Consultant Advice Notice

Thornbury House – 716 High Street, Thornbury VIC 3071

Addendum to Acoustic Town Planning Report

PLAN LEVEL 7

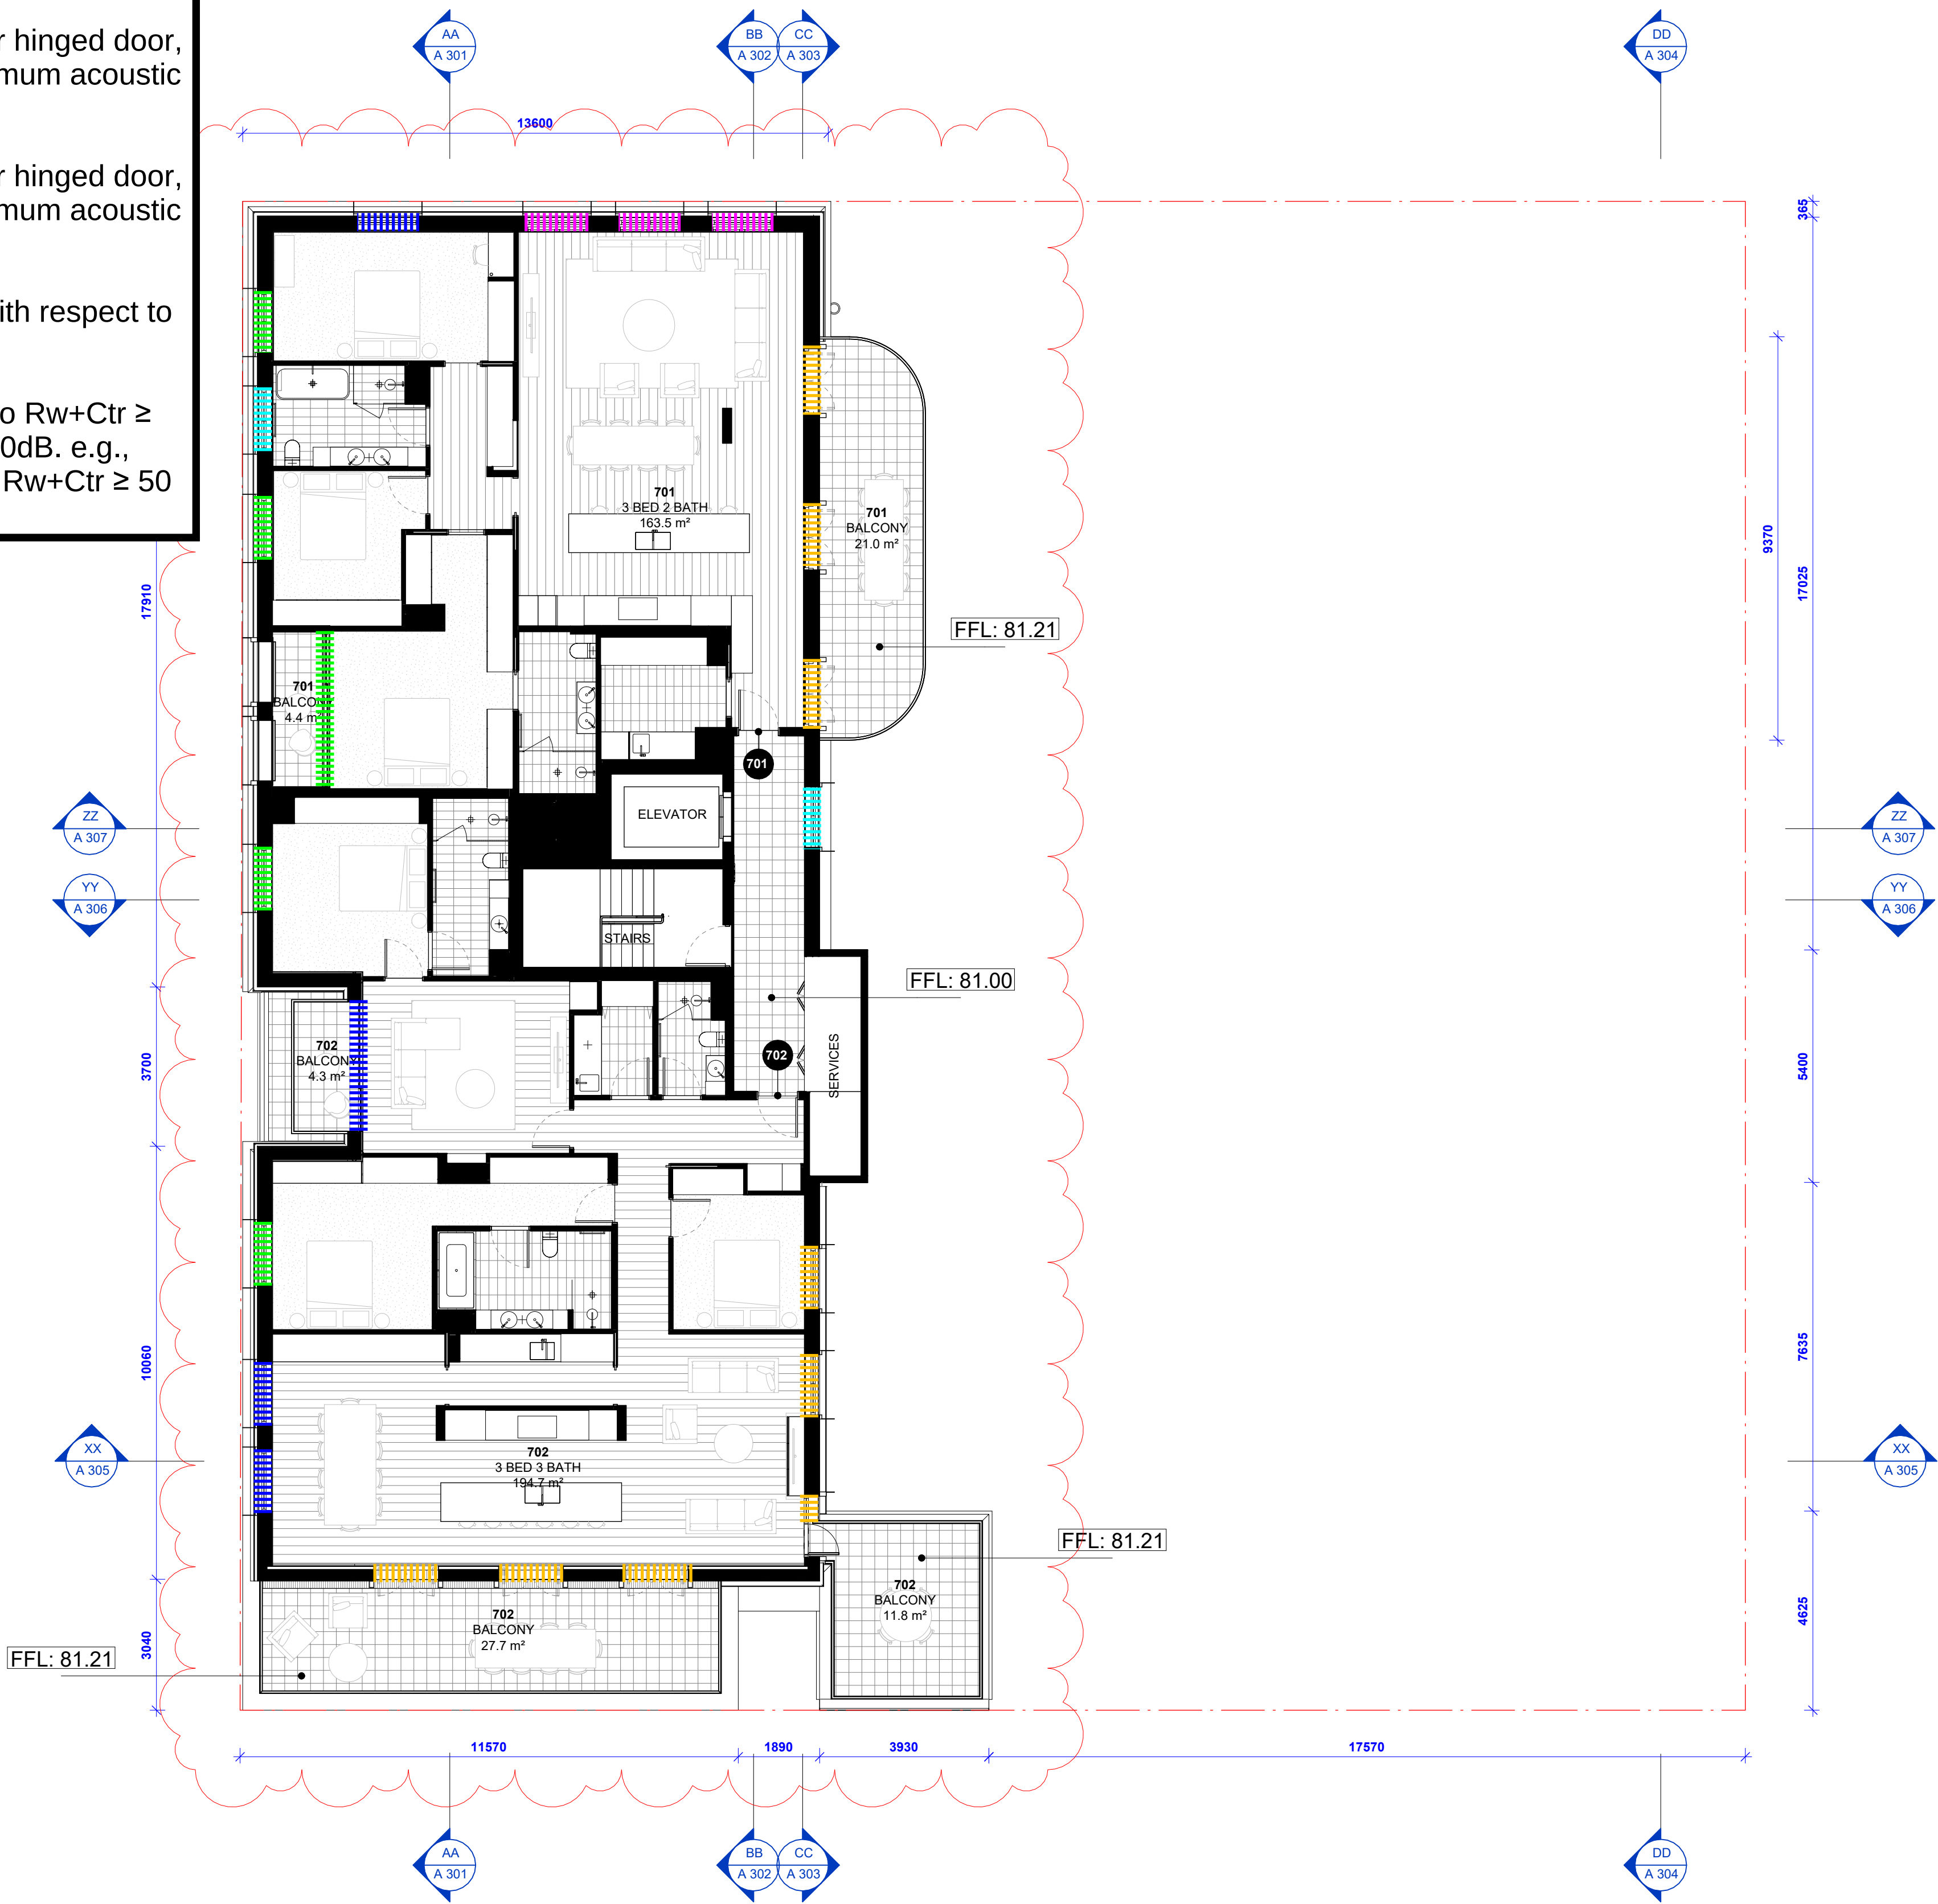
Fixed/awning glazing, sliding door or hinged door, including any frames and seals to have a minimum acoustic rating of Rw 40.

Fixed/awning glazing, sliding door or hinged door, including any frames and seals to have a minimum acoustic rating of Rw 38.

Fixed/awning glazing, sliding door or hinged door, including any frames and seals to have a minimum acoustic rating of Rw 36.

Fixed/awning glazing, sliding door or hinged door, including any frames and seals to have a minimum acoustic rating of Rw 32.

Opaque sections of the façade shall be rated to $Rw+Ctr \geq$ the glazing performance requirement (Rw) + 10dB. e.g., opaque section of the facade shall be rated to $Rw+Ctr \geq 50$ proximate to Rw 40 rated glazing.

LEVEL 8 GA PLAN (ROOF)

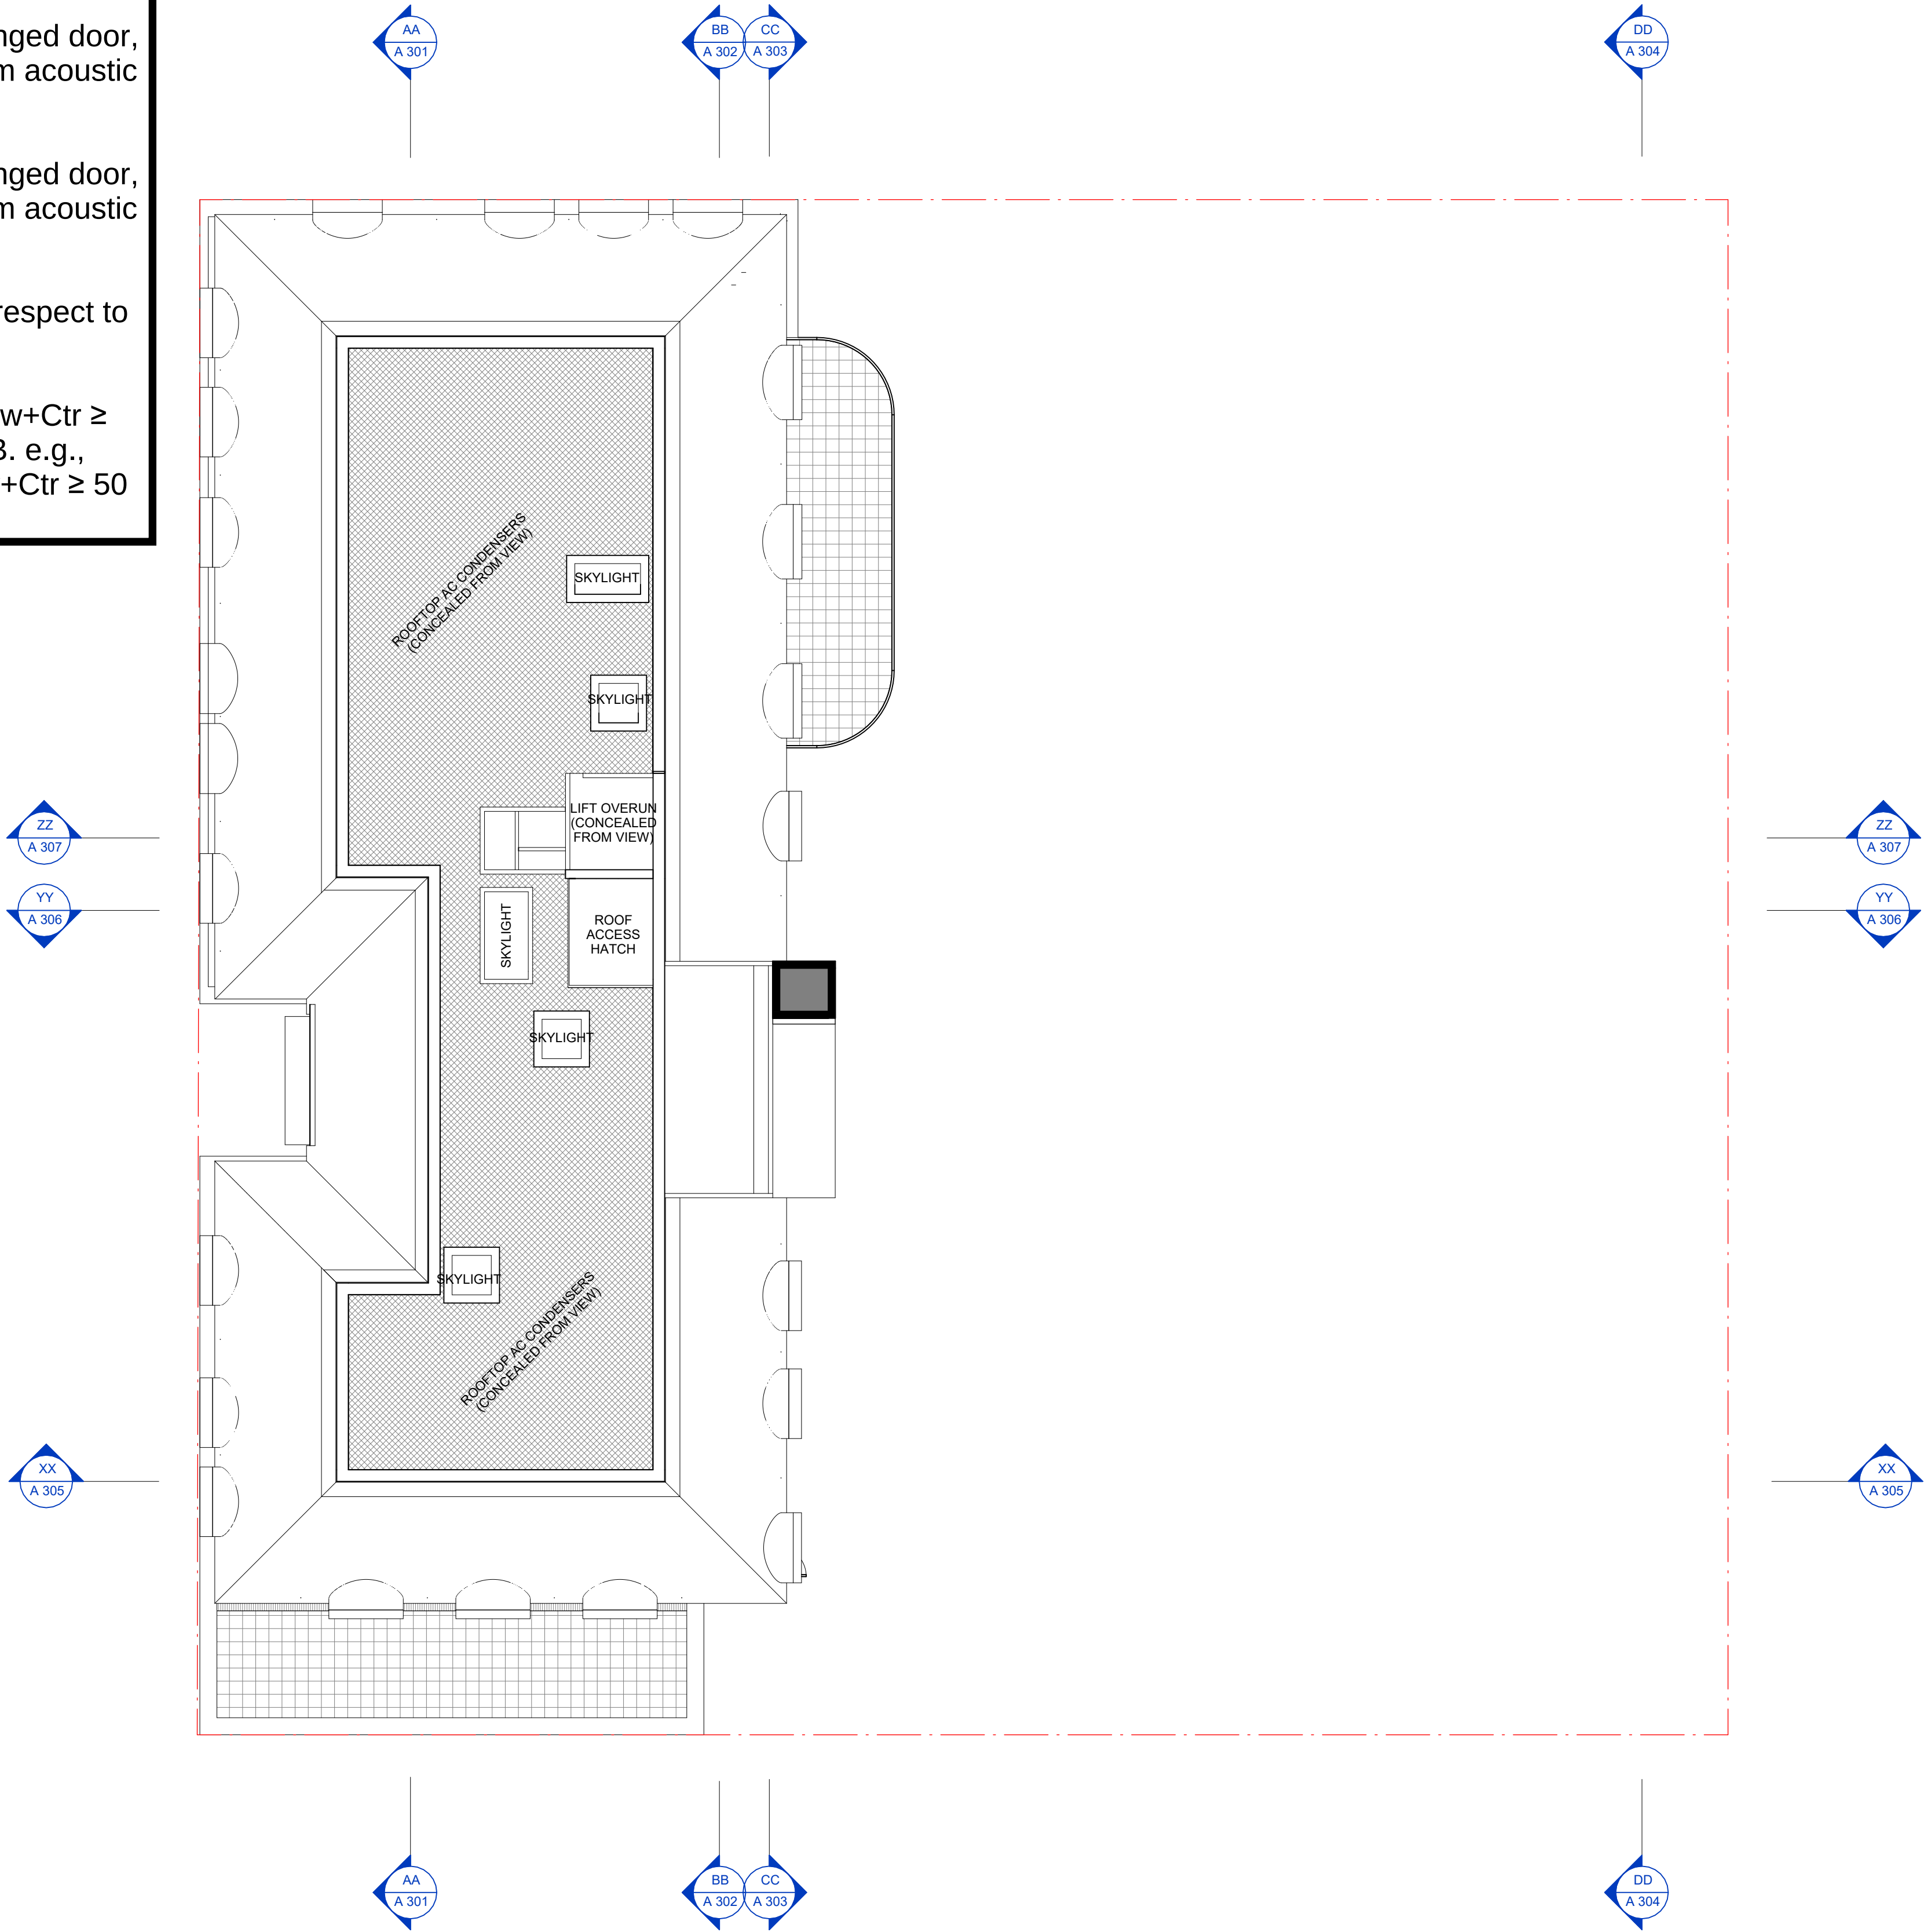
Fixed/awning glazing, sliding door or hinged door, including any frames and seals to have a minimum acoustic rating of Rw 40.

Fixed/awning glazing, sliding door or hinged door, including any frames and seals to have a minimum acoustic rating of Rw 38.

Fixed/awning glazing, sliding door or hinged door, including any frames and seals to have a minimum acoustic rating of Rw 36.

Fixed/awning glazing, sliding door or hinged door, including any frames and seals to have a minimum acoustic rating of Rw 32.

Opaque sections of the façade shall be rated to $Rw+Ctr \geq$ the glazing performance requirement (Rw) + 10dB. e.g., opaque section of the facade shall be rated to $Rw+Ctr \geq 50$ proximate to Rw 40 rated glazing.
